DEVELOPMENT OF BRISTOL AIRPORT TO ACCOMMODATE 12 MILLION PASSENGERS PER ANNUM (REF 18/P/5118/OUT)

Response to North Somerset Council Flood Risk Management Team Comments

POST-DEVELOPMENT SURFACE WATER
EXCEEDANCE FLOW ROUTES
(SHEET 2 of 2)

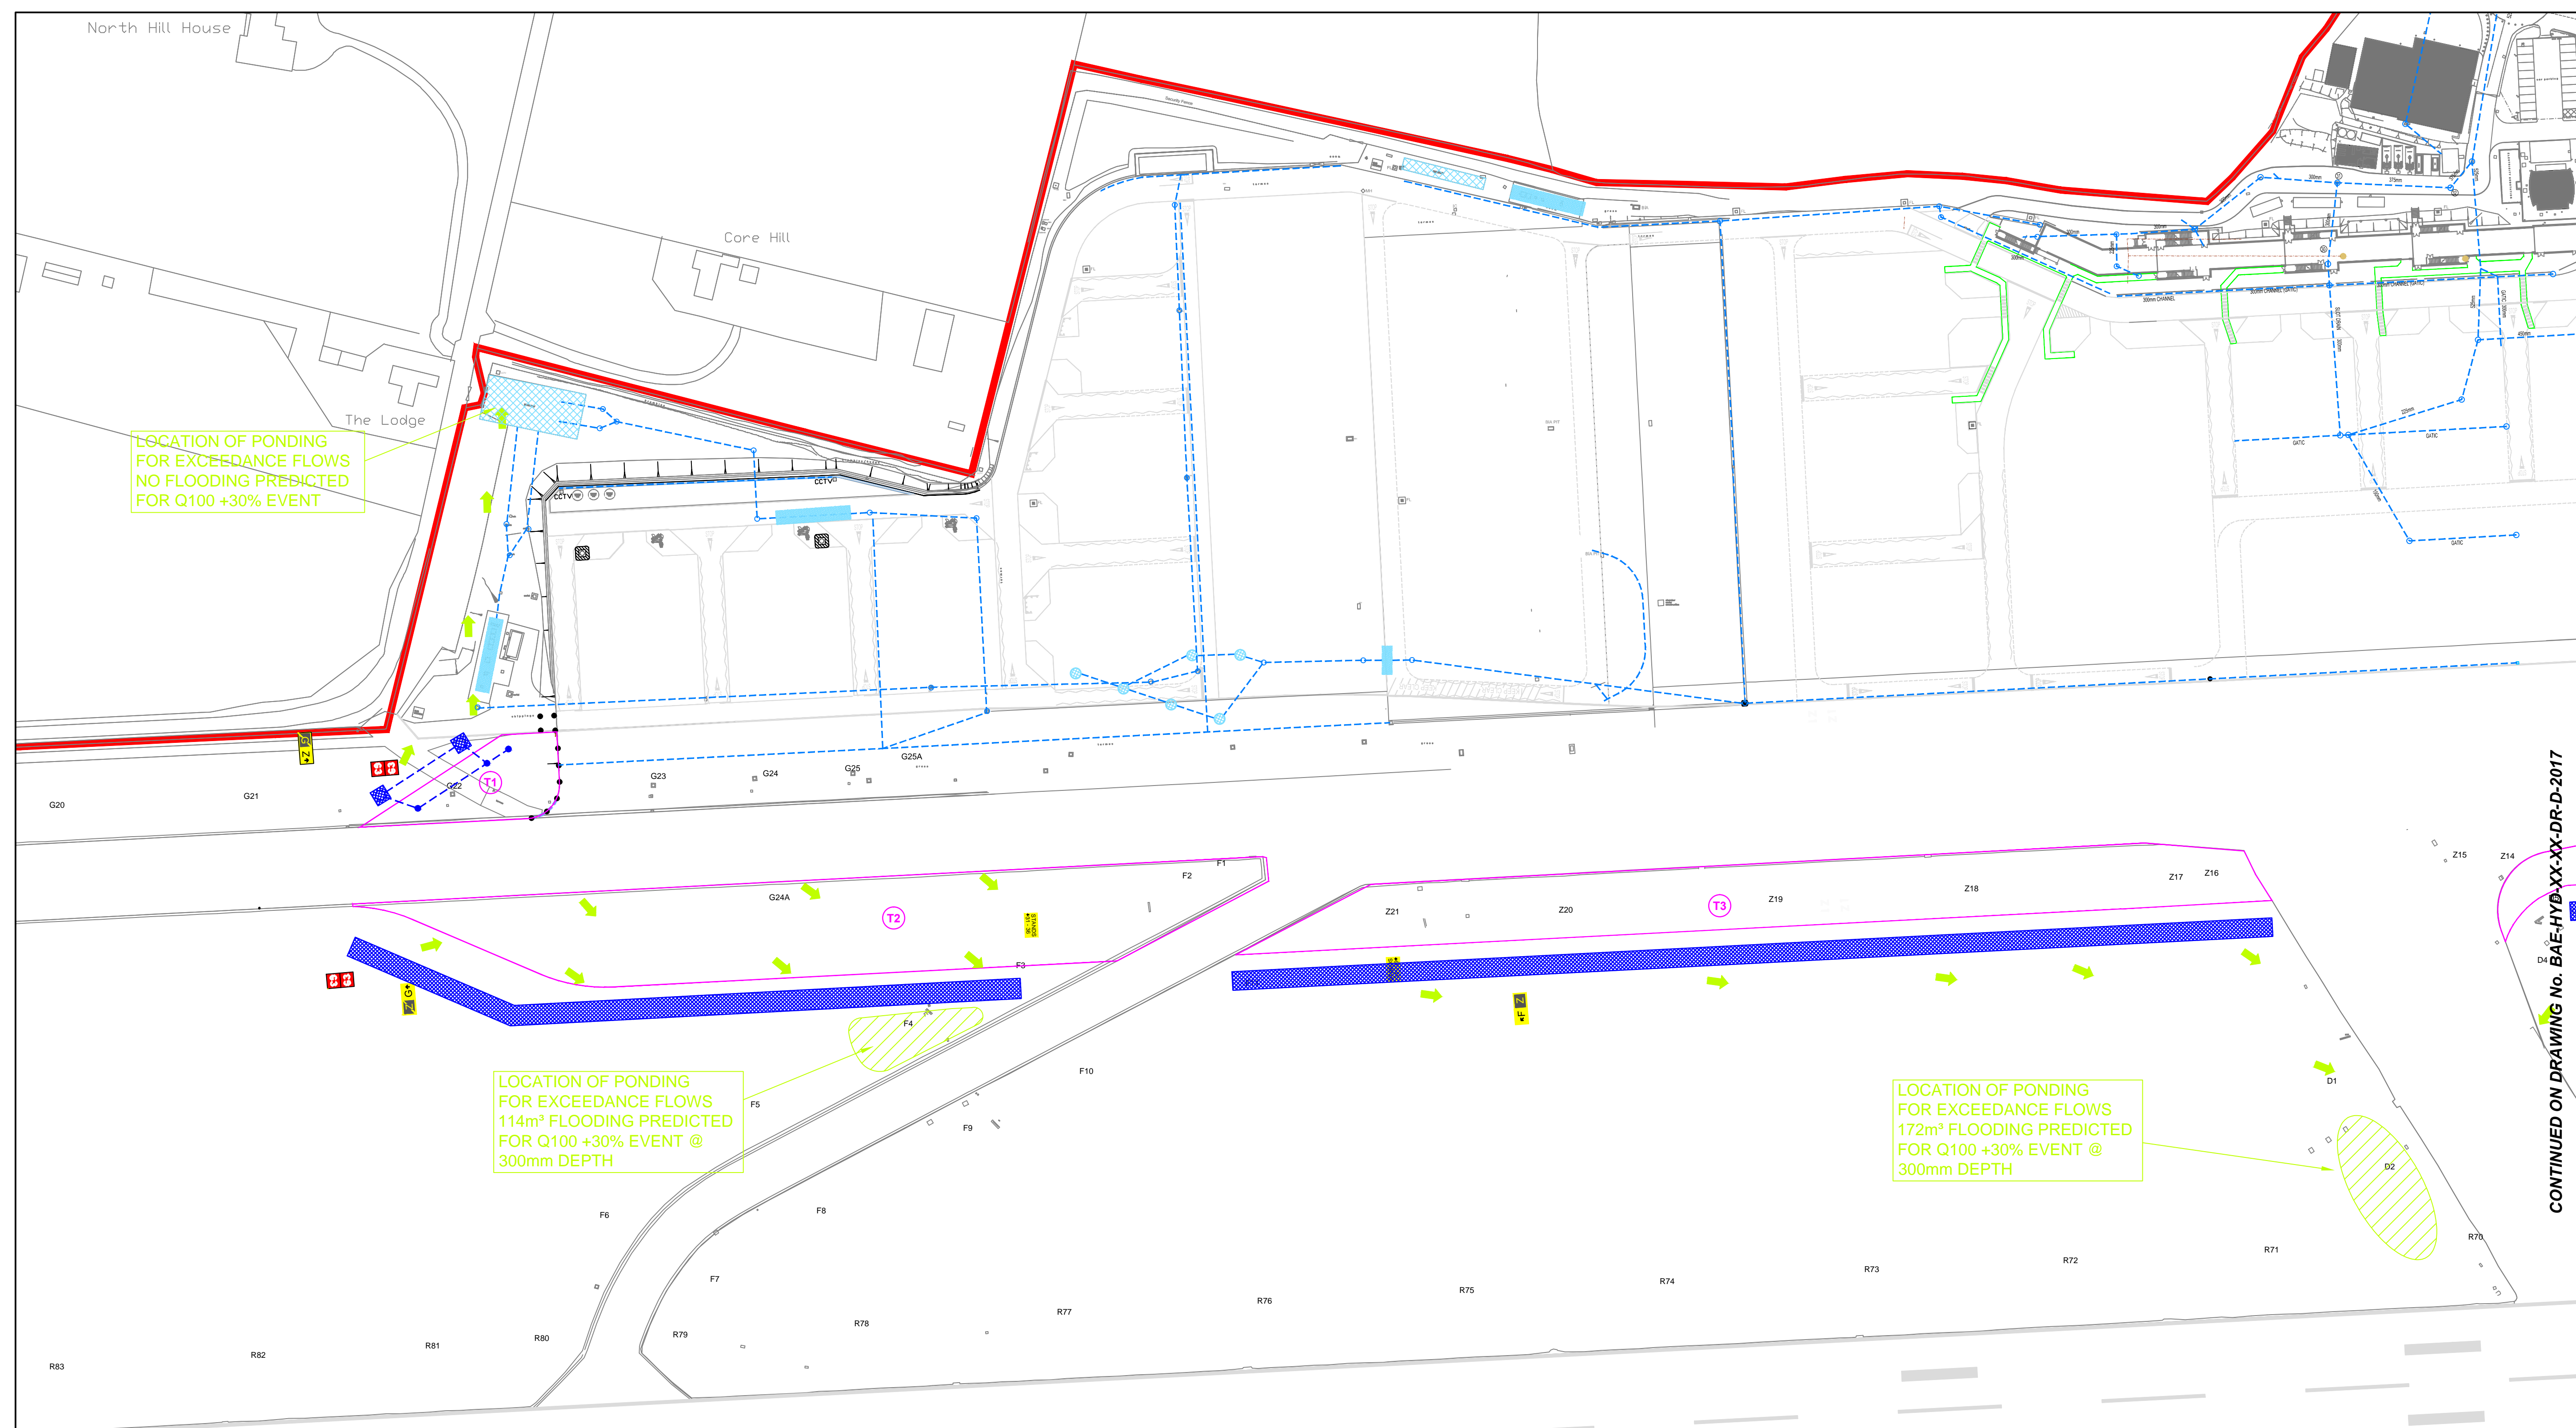
- *Factors of safety for the design of infiltration structures to be as stated above and based on current best practice guidance including the CIRIA SuDS Manual C753. If the applicant disagrees with this best practice guidance or any of the recommended infiltration drainage design factors of safety, then evidence to justify a lower factor of safety should be submitted in support of this application.*
- *Network calculations for full planning application sections of surface water infrastructure, with a matching plan showing corresponding pipe numbers.*
- *Exceedance flow routing plan for the site that identifies overland flow paths during an exceedance event and that confirms flood risk will not be increased elsewhere.*

An overall flood exceedance plan has now been prepared to indicate where any excess flows can be routed and the resulting volumes can be stored. This information is shown on Hydrock drawing nos. BAE-HYD-XX-XX-DR-D-2017-P01 and BAE-HYD-XX-XX-DR-D-2018-P01 which are submitted alongside this Note.

The Drainage Strategy seeks to demonstrate that any exceedance flows from soakaways will be contained within the overall airport site and will not affect third party land. In the 100 year plus climate change event, depths of any ponding should not exceed 300mm. The consequences of any exceedance flows from a soakaway unit are therefore based on an engineering judgement to be made by BAL and taking into account the effect on its operations or the safety of the public and staff within the airport site.

For the reasons set out above, and from the provision of the exceedance flow plan demonstrating how any potential flood flows can be directed and stored, an overall factor of safety of 2 is judged to be appropriate in these circumstances.

An indicative exceedance flow routing plan has been prepared to accompany the Drainage Strategy, showing the likely paths of overland flows and where these will be contained to prevent off-site flows, based upon the current topography of the site. This information is shown on Hydrock drawing nos. BAE-HYD-XX-XX-DR-D-2017-P01 and BAE-HYD-XX-XX-DR-D-2018-P01 which are submitted alongside this Note.

A detailed Exceedance Flow Routing Plan can be completed as part of individual component of the scheme at the design stage. Furthermore, BAL would not object for this to be conditioned if required.
